<b>marantz®</b> <b>SERVICE BULLETIN</b>		Date: 30-June-2003	Model: SR4300,SR4400
		Page: 1 / 1	REF.NBR: MZ03-023
Circulation:		Subject:	
Application:		The sound is interrupted, when the playback DIGITAL of CD-R/RW of the SCMS signal.	
x for information customer complaint in case of service mandatory .....		Int.ref:	
See Below

<b>marantz®</b> <b>SERVICE BULLETIN</b>		Date: 31-Oct.-2003	Model: SR4300/SR4400
		Page: 1 / 3	REF.NBR: MZ03-047
Circulation:		Subject:	
Application:		The problem of the Speaker protection circuit.	
x for information customer complaint in case of service mandatory .....			
		Service code XE00 XE00xxxxxxxxxx

<b>marantz®</b> <b>SERVICE BULLETIN</b>		Date: 30-June-2003	Model: SR4300,SR4400
		Page: 1 / 1	REF.NBR: MZ03-025
Circulation:		Application:	
x for information customer complaint in case of service mandatory .....		See Below	
		Int.ref:

**SR4300**

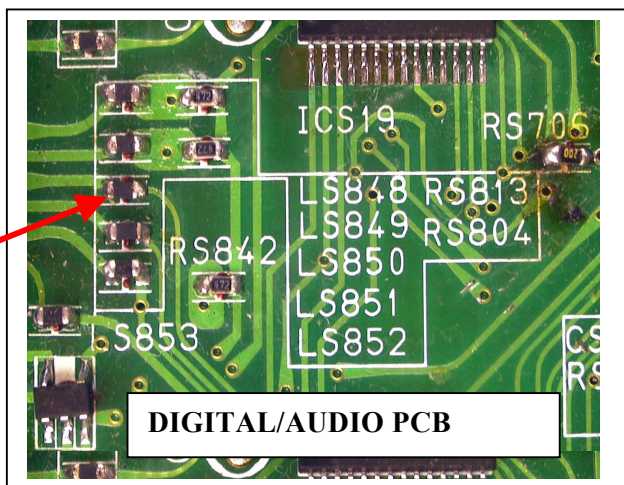
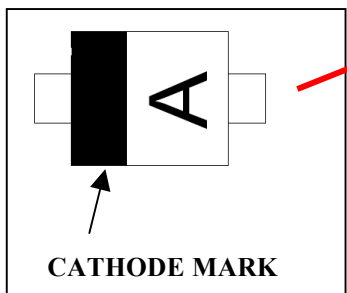
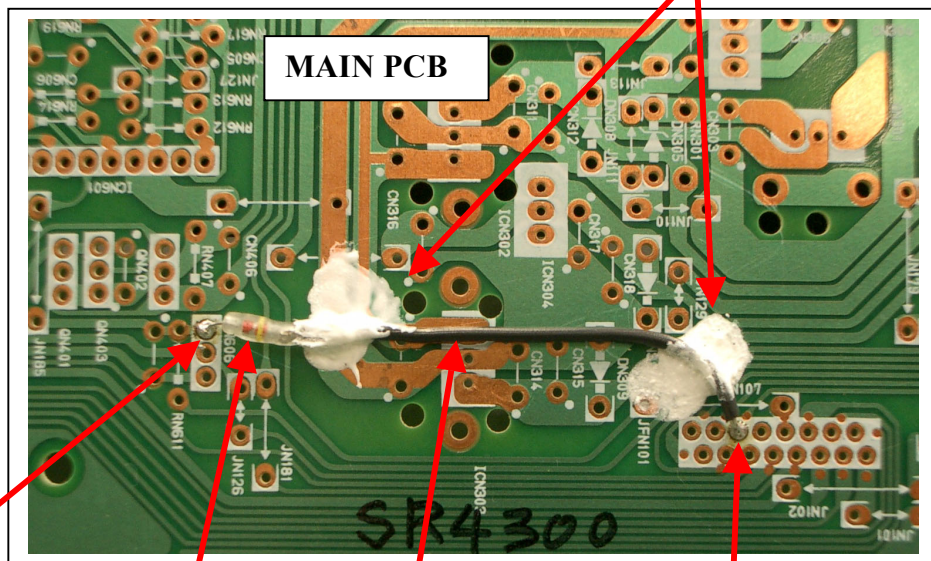
LS850 is changed to  
Part no. \*HD201810R

**Caution**  
JFS08 (FPC CONNECTOR) side is  
CATHODE

BASE of QN606

DN601  
Part no. HD20002000

No.5 pin of JFN101

Insulation tube is used

- 1) Chip Resistor **LS850** (100 ohm 1/16W part no. NN05101610 ) is changed to **Silicon Diode (Part no. \*HD201810R--- 1SS400 POHM: EMD2, EIAJ: SC-79, JEDEC: SOD-523 )**.

- 2) Chip Resistor **DN601(Part no.HD20002000---Silicon Diode 1SS254 ROHM)** is added between BASE of QN606 SEMICOM.COMP and No.5 pin of JFN101 Connector

SR4400

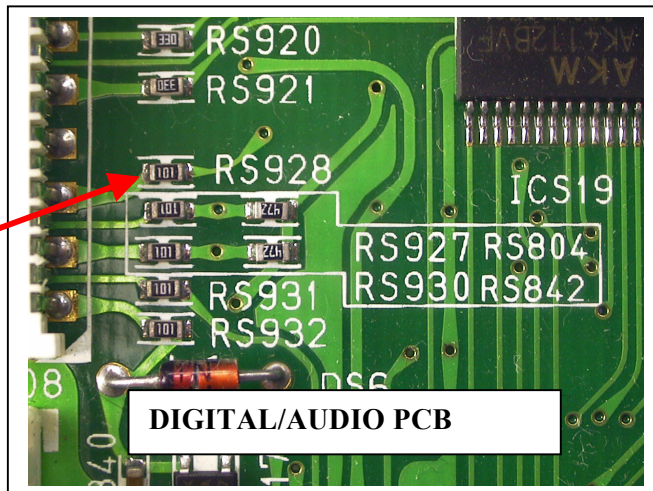
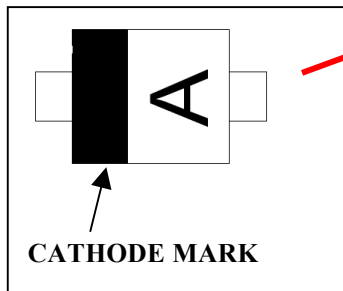
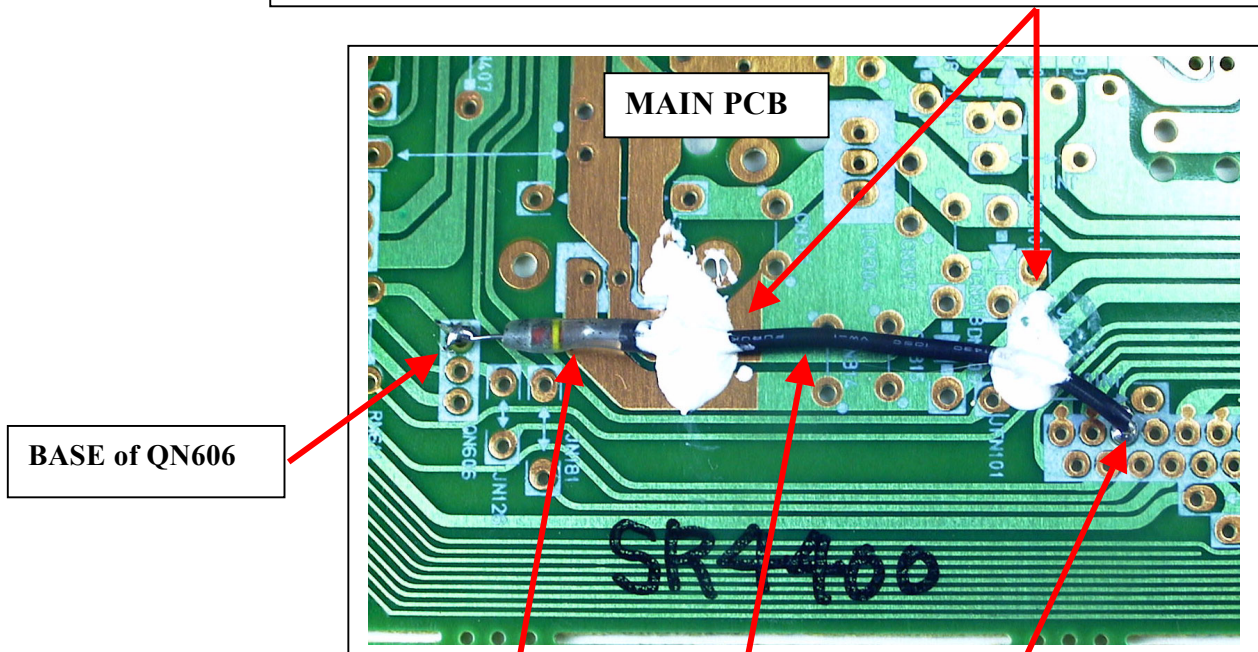
RS928 is changed to  
Part no. \*HD201810R

**Caution**  
JFS08 (FPC CONNECTOR) side is  
CATHODE

DN601  
Part no. HD20002000

No.5 pin of JFN101

Insulation tube is used

- 1) Chip Resistor **RS928** (100 ohm 1/16W part no. NN05101610 ) is changed to **Silicon Diode (Part no. \*HD201810R--- 1SS400 POHM: EMD2, EIAJ: SC-79, JEDEC: SOD-523 )**.

- 2) Chip Resistor **DN601(Part no.HD20002000---Silicon Diode 1SS254 ROHM)** is added between BASE of QN606 SEMICOM.COMP and No.5 pin of JFN101 Connector
